S E R V I C E N O T E

4957PC Protocol Analyzer

Auto-Configuration Anomaly

Fig. 1

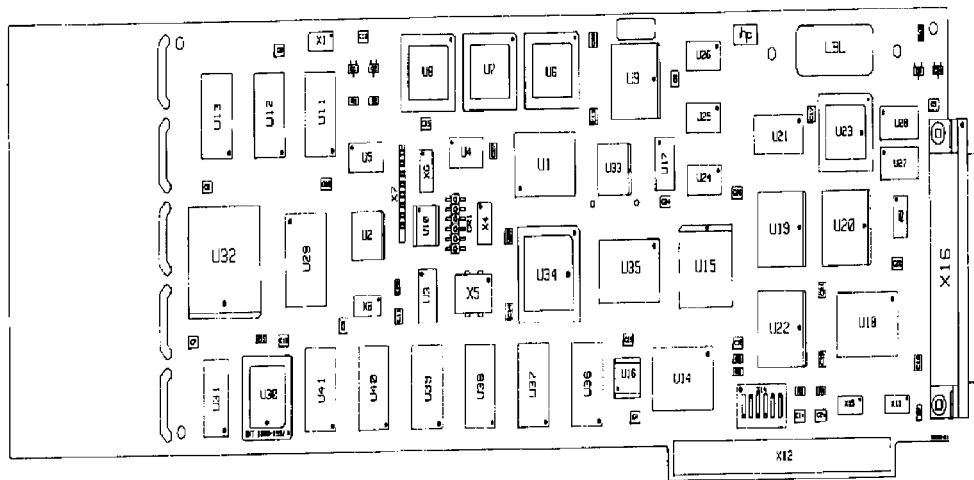
When Auto-Configuration is used on a network that is a BOP protocol, the data is DCE and the clock source is from the DCE, the 4957A will either not synchronize on the data or the 4957A will take an excessive amount of time to configure. One case was a setup for HDLC, ASCII8, 1200 bps, DTE clock = DCE, and Mode = Sync.

Referencing Figure 1, locate the three ROMS in the upper center of the PC board. Remove the three ROMS from their sockets, noting the orientation of the ROM in the socket. Place the new ROMS in the sockets in the following matter:

Ref. Desg.	Old Part No.	New Part No.	
U6	04957-19009	04957-19025	(Standard)
	04957-19014	04957-19027	(Option 001)
U7	04957-19010	04957-19024	
U8	04957-1911	04957-19026

Place PC Card into computer and run the HPTools application. AT the Top Level Menu of the 4957PC, press MORE key and enter the Self Test Menu. Run the Self Test Loop test to verify the operation of the card.
